RESTORATION OF WESTBY LANDFILL SITE

AFTERCARE SCHEME

Planning Permission LCC/2018/0019 Condition 28

**Discharge of Condition 27 of Permission LCC/2018/0019/1
Westby Landfill Site, Fylde, Lancashire**

Job Title	WESTBY LANDFILL SITE WESTBY BLACKPOOL FY4 5JX		<p>29 Bradford Road Eccles Manchester M30 9FF Tel: 07966 470 358 info@oakbaydesign.com</p>
Drawing Title	LANDSCAPING PLAN SHOWING FINAL RESTORATION CONTOURS		
Scale	1 : 2000 @ A3	Date	OCTOBER 2019
Drawing No.	Z311.001	Rev.	3

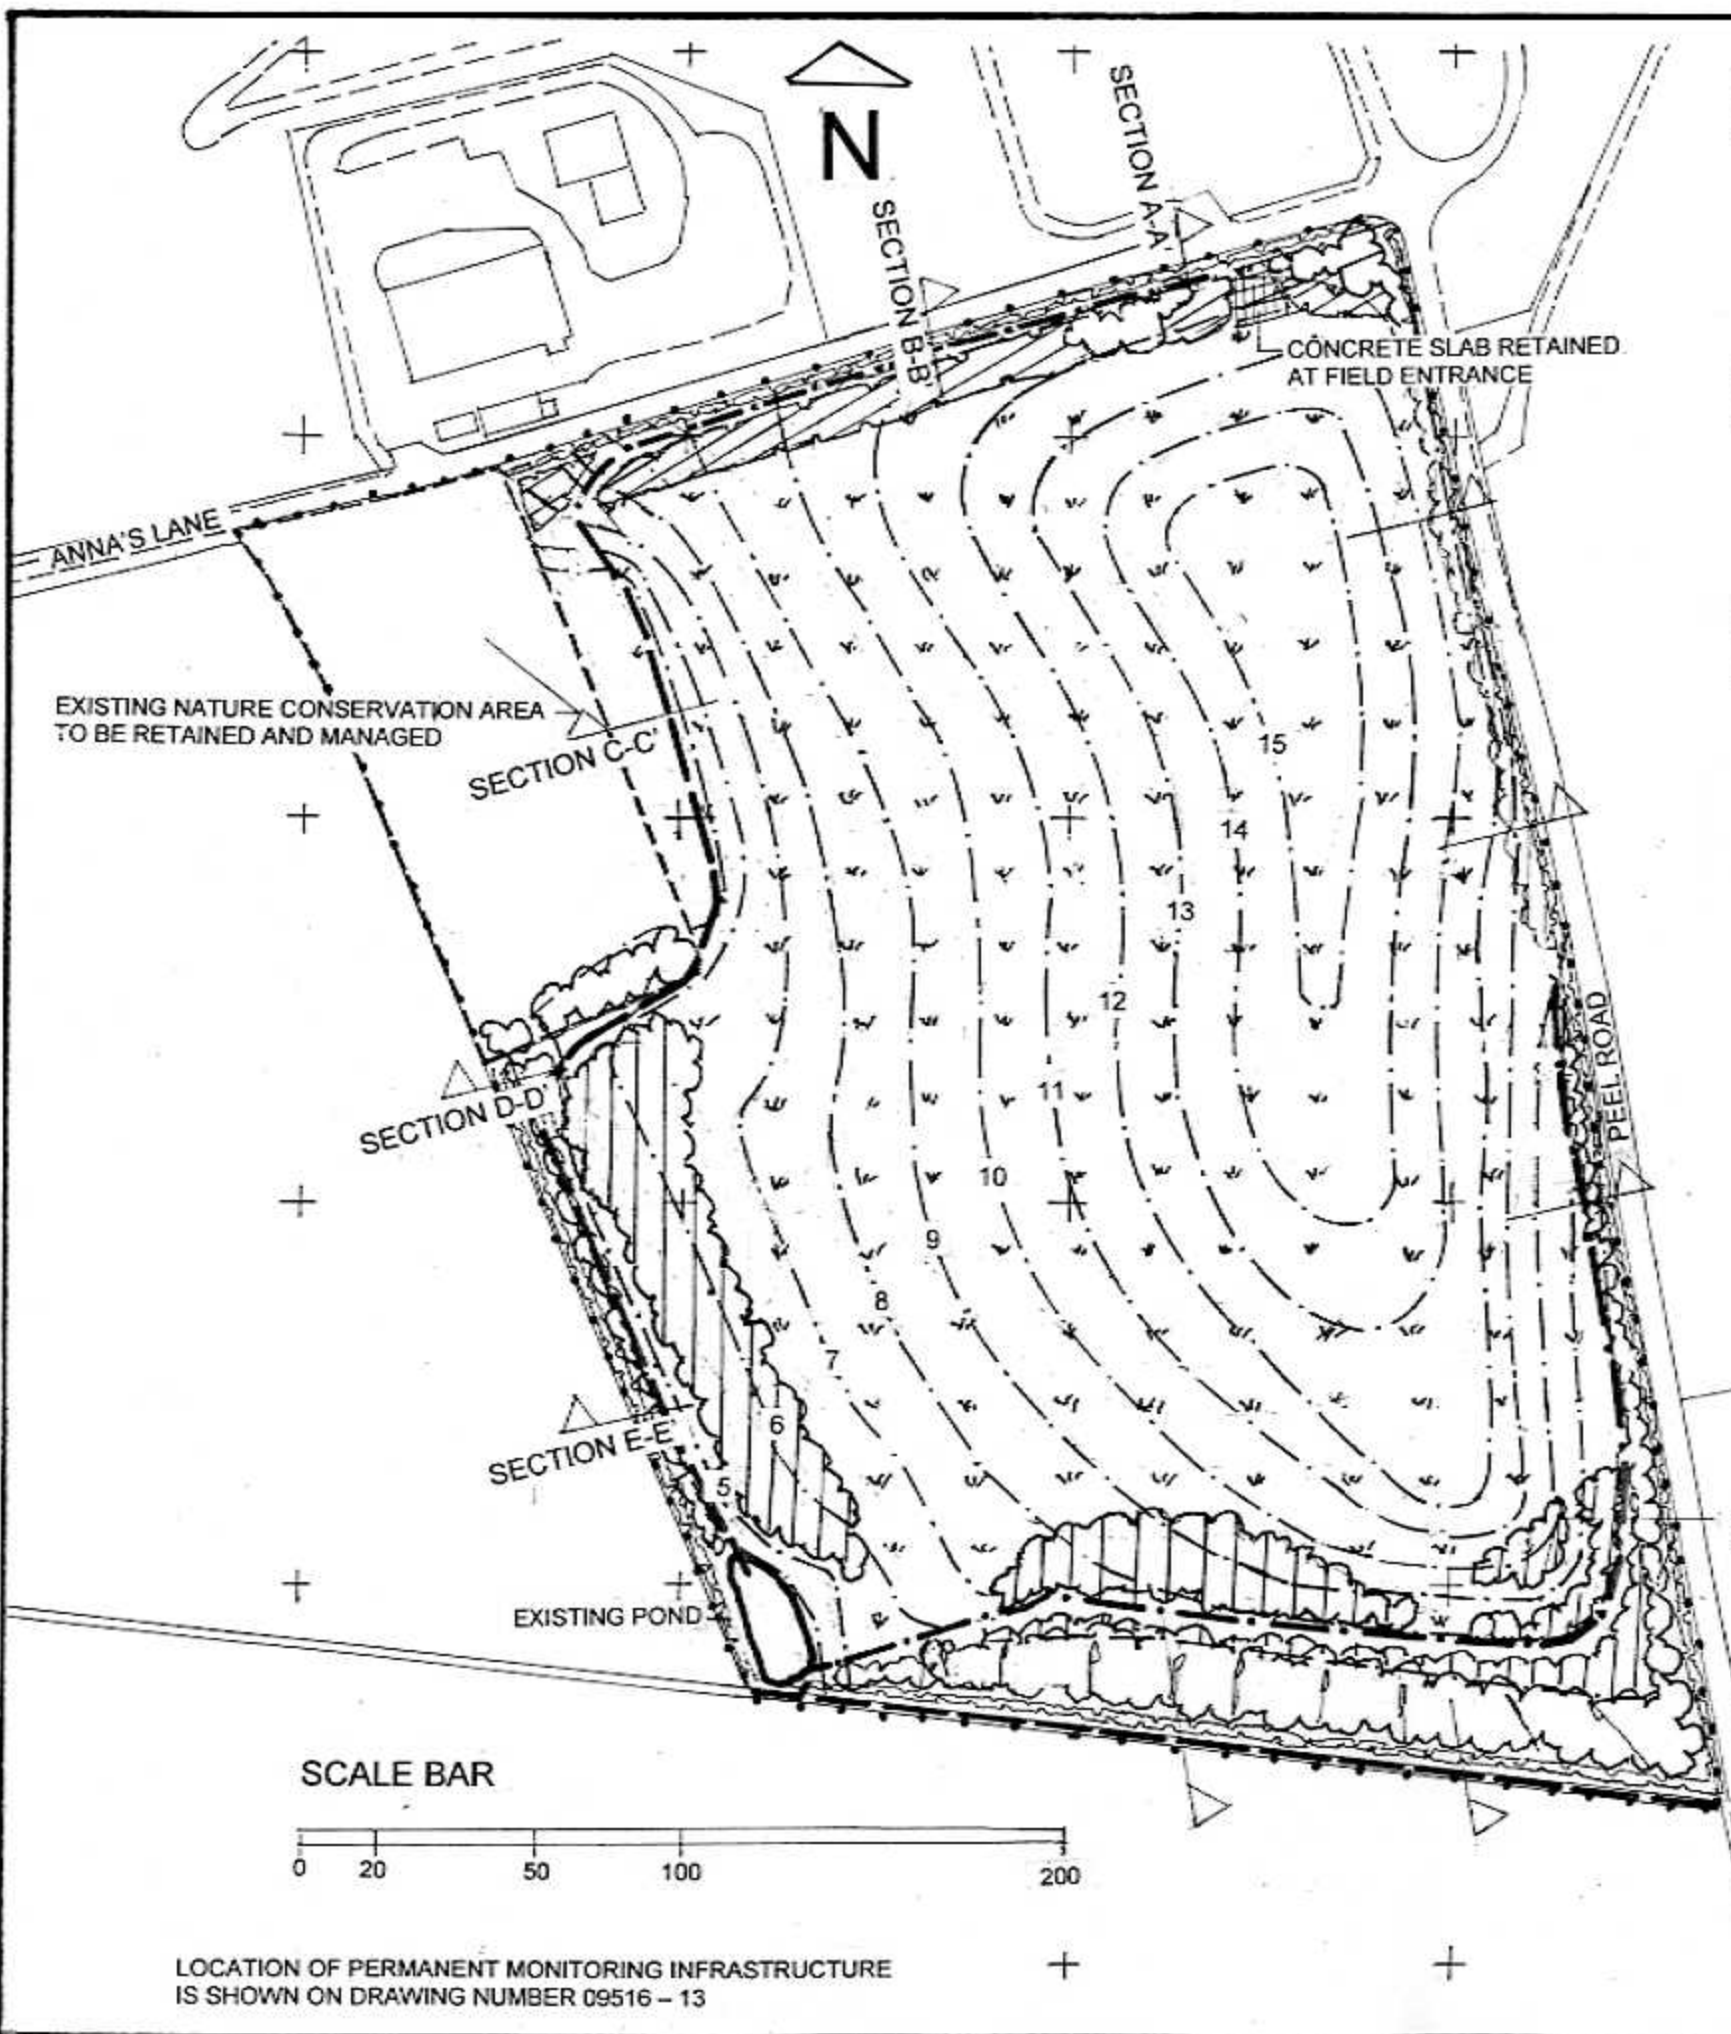
The applicant should submit soil analysis sheets to the planning authority prior to scheme commencement, to ensure compliance to BS 3882:2015² for the proposed recycled topsoil? The applicant should also confirm the final volume proposed to be used, currently listed as to a depth of '10mm'?

Can the applicant check and confirm the stated topsoil depths for grassland and planting areas, as these are deeper than recommended in Design Manual for Roads and Bridges, Volume 10, Section 1, Part 2, New Roads: Planting, Vegetation and Soils and BS3882:2015 Specification for topsoil? In reassessing the required topsoil depth, the applicant should also provide subsoil levels to help explain the total soil formation depth. The depth of soil should also take into account slope gradient, to ensure that it is sufficiently stable on placement.

For woodland some further clarification is required in terms of groupings and positions within the plot. i.e. larger tree species and shrub species.

Further clarification is also required for the tree protection which is currently listed as a 'plastic tree guard secured with a 1 metre high cane'. Further specification information is needed to understand the proposed type of tubular guard to be used and the dimension size. Correspondingly, the height and thickness of the stake should be stated, including the number of ties to attach to the guard and that the wood is to be obtained from a Forestry Stewardship Council (FSC) approved source

Should any permanent monitoring infrastructure be found to be required, the applicant should include this on Drawing No. Z311.001 or if shown on a separate drawing, refer to this drawing as a note.

The applicant should also note on the drawing the future access arrangements to the site from Anna's road and whether any hard stand at the entrance is proposed.

This is not the depth but the particle size to which the recycled topsoil is produced ie. not greater than 10 mm. The volume will be as follows:

The DMRB guidance does not address landfill restoration. Landfill restoration is regulated by the permit. The EA generally allow 1 m depth of restoration soil. Included in this is a maximum depth of 450 mm topsoil. The proposed 300 mm for grassland is within this specification and the 500 mm proposed for shrubs and trees will be reduced to 450 mm.

Shrub species (Hawthorn, Willow) will be positioned to the fore of the planting bed with tree species (Alder, Cherry, Birch, Oak) forming a core in the centre. Planting will be in groupings of 5, 7 and 9.

Species will be randomly planted in groups of 5, 7 and 9.

Trees will be small whips with a maximum height of 600 mm, as detailed on drawing Z311.001. Staking will not be required, this is generally undertaken for trees above 1 m high. Plastic spiral rabbit guards will be applied, supported by a bamboo cane. The cane acts as a support to secure the rabbit guard. The guards are polypropylene, 600 mm high and expand from 3 to 15 cm in diameter.

Permanent infrastructure would include leachate and gas wells capped off at ground level. The location of these are shown on Drawing No 09516-13C however this will be added to as the landfill site progresses, particularly with the addition of in waste gas monitoring boreholes. The exact location of these will be determined post infilling in accordance with

An area of hardstanding will be retained inside the access gates as shown on the revised landscaping plan.
